**Benton County Planning Board**

**Planning Division**

**SITE PLAN REVIEW PLANNER'S TECHNICAL REPORT**  
**Carroll Electric Service Station**  
**10720 N AR Hwy 59, Gravette AR**

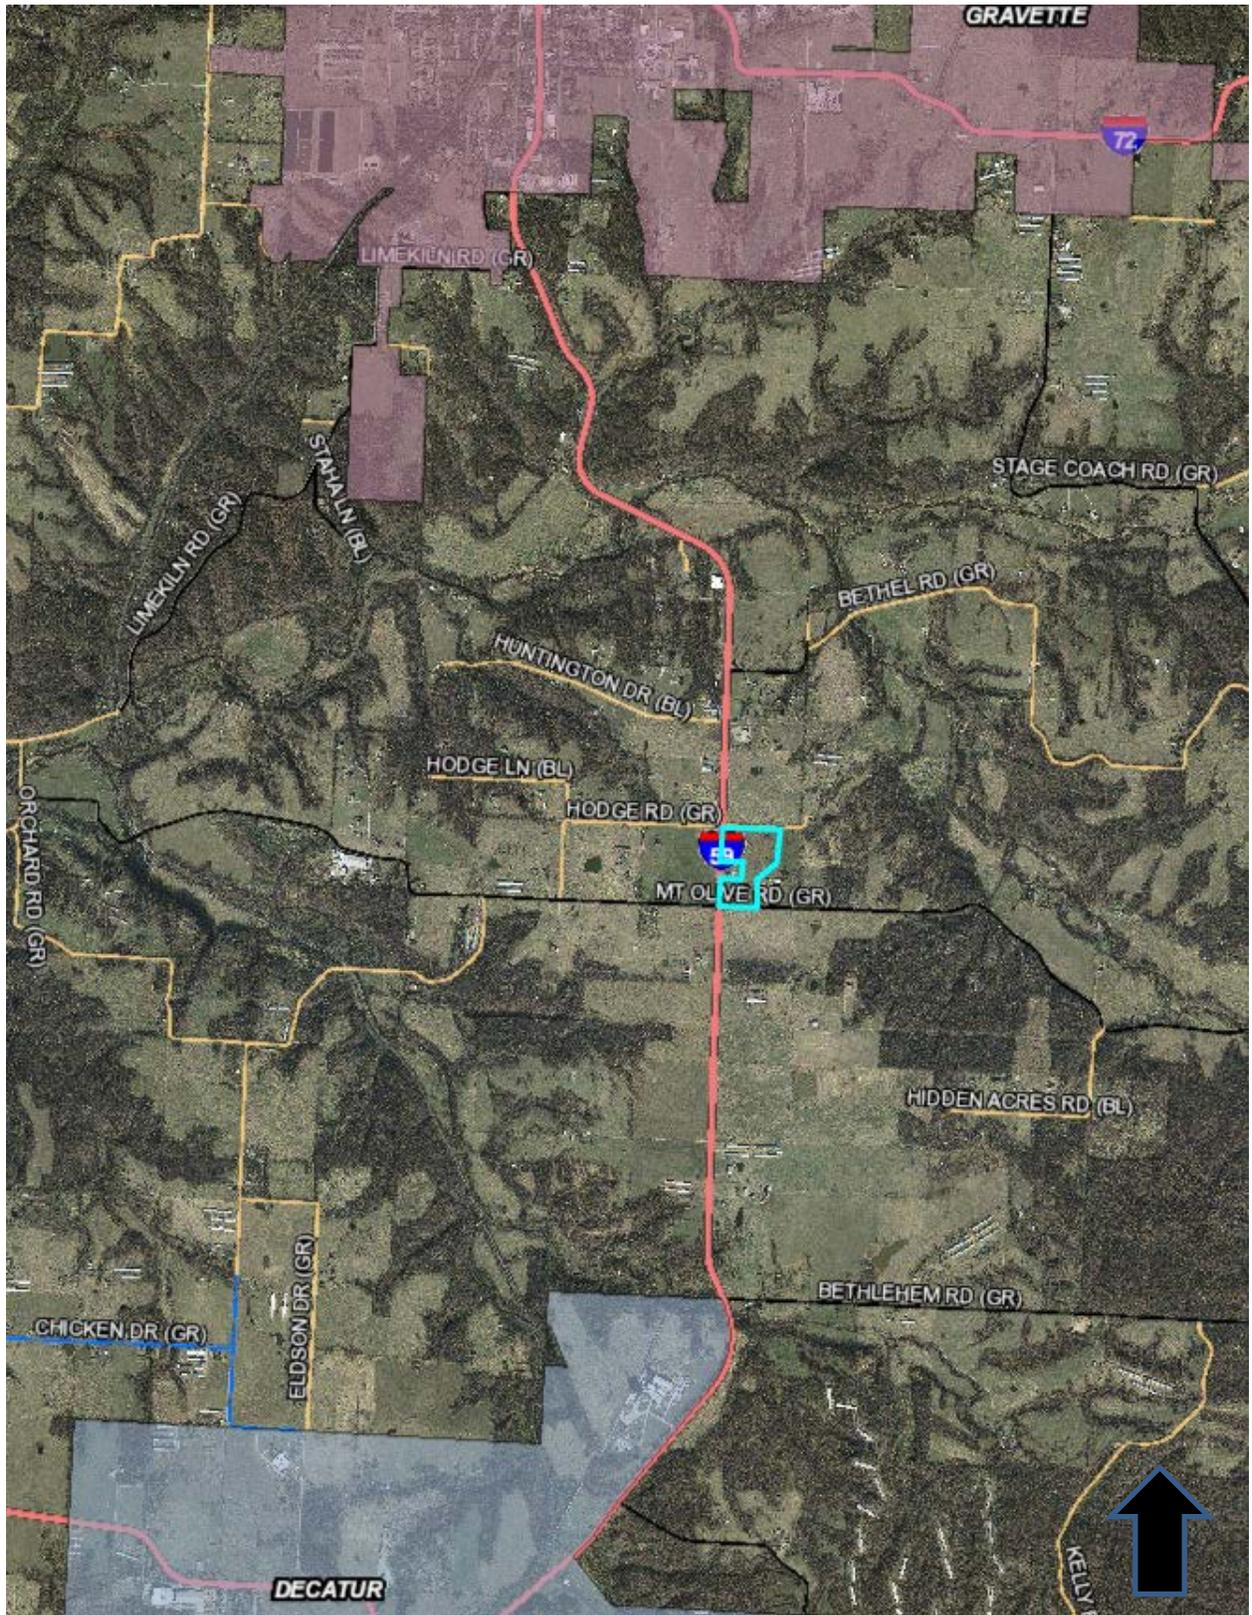
1. Site Plan revisions to include the following: Insert Parking Table as follows; 1.) Parking calculation for the using 'Office' and 'Warehouse'; 2.) Notate number of parking spaces provided; Correct front, side, and rear building-to-property line set-back lines; Detail location of dumpster on site (if necessary); Remove internal 'lot' and 'tract' property lines; Detail any outdoor lighting on site plan, include full cut off lighting note.
2. Drainage statement / cover letter from Certified Engineer confirming the adequacy of Stormwater management on-site, supported by both pre-development and post-development runoff coefficients, indicating on-site stormwater management systems will mitigate/eliminate site runoff resulting from increased impervious surfaces. Statement / cover letter shall provide pre and post-development

- impervious cover calculations. Provide a copy of the SWPPP and ADEQ NOC that will be posted on site.
3. Landscaping plan shall be revised to meet the County required buffering/screening for 'Questionable Compatibility' detail in Table 6.6.

The proposed 18,500 +/- sq. ft. commercial building was reviewed by planning staff to ensure compliance with the Planning and Development Regulation of Benton County. The project must revise its site plan as detailed in the 'outstanding items' above. Further, the inset detail showing how compatibility requirements for landscape buffering will be achieved shall be tied to the issuance of a decision letter. Finally, a drainage letter must be approved by a licensed engineer in the State of Arkansas to affirm that finished grades and additional impervious cover will not adversely impact surrounding property, and, that the site can adequately retain and disperse stormwater runoff .
